Advisory Committee Meeting

August 15, 2024

# Data Collection and Evaluation Report FY 2022/23

**Figure 3-1. Comparison of 2019-23 Actual Data versus 2020 SYR Projection for Urban Outdoor Water Use, FY 2019-2023**

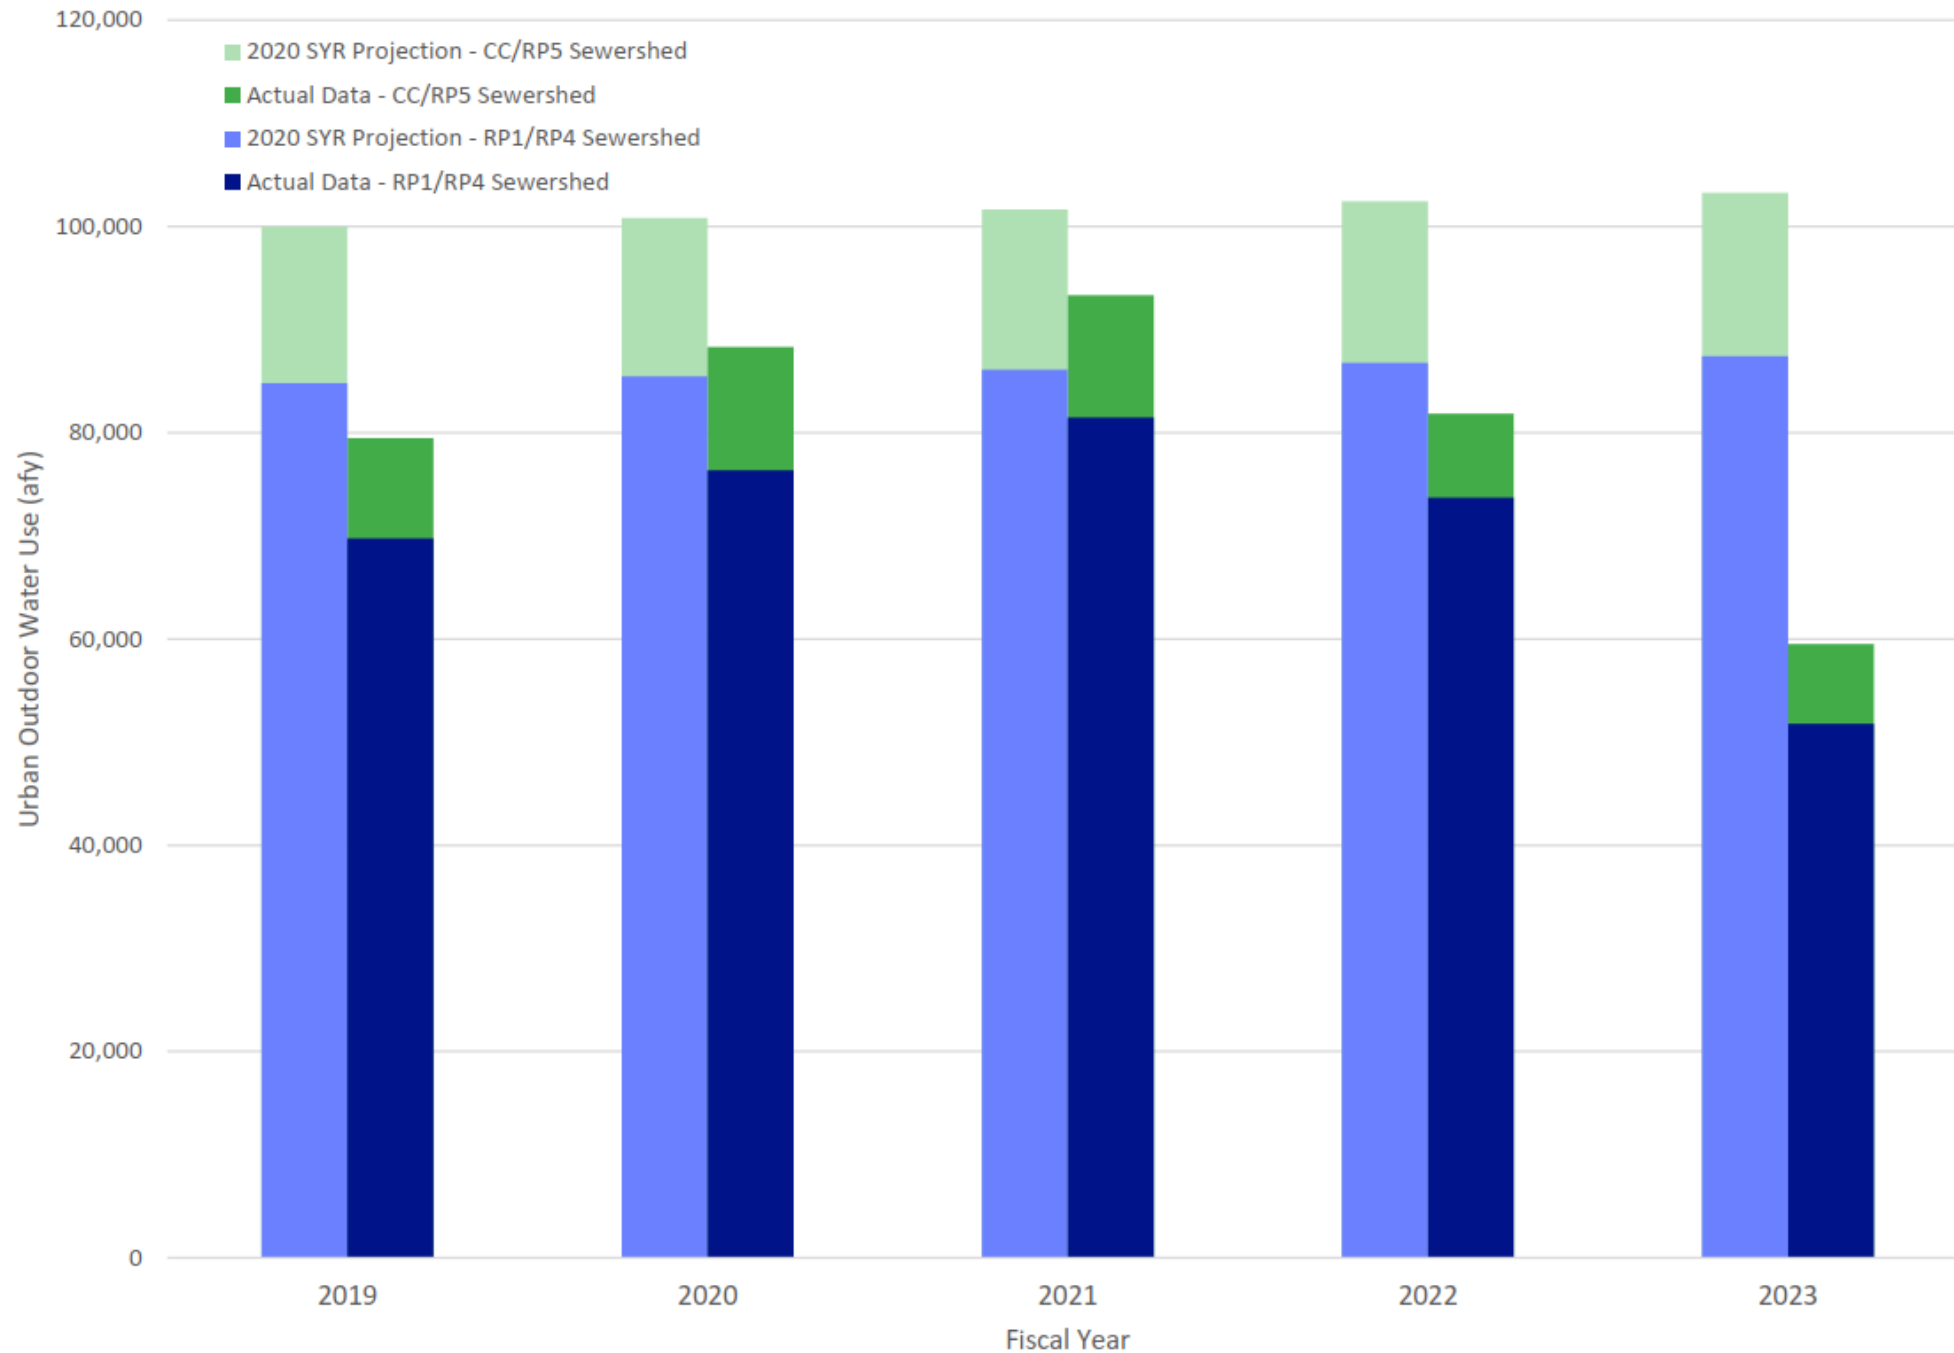
Section 3.3.3 – Potential reduced net recharge due to differences in outdoor water use focuses on applied water without considering other factors (i.e., precipitation and imported water restrictions). Actual irrigation efficiency is less than assumed in the report.

- The scope is limited to evaluating the impacts of cultural conditions, including applied water (excludes precipitation).
- Patterns in cultural conditions are evaluated in the context of historical hydrology; hydrologic impacts on outdoor water use are described qualitatively.
- Detailed quantitative analysis of hydrologic impacts is beyond the current scope; will be considered in the 2025 Safe Yield Reevaluation.
- Historical period includes dry (2020-2022) and wet years (2019, 2023); actual outdoor water use is consistently less than 2020 SYR Projection.
- Revised report to clarify assumptions, resulting in impacts ranging from 4,000 to 8,000 afy compared to 2020 SYR Projection.
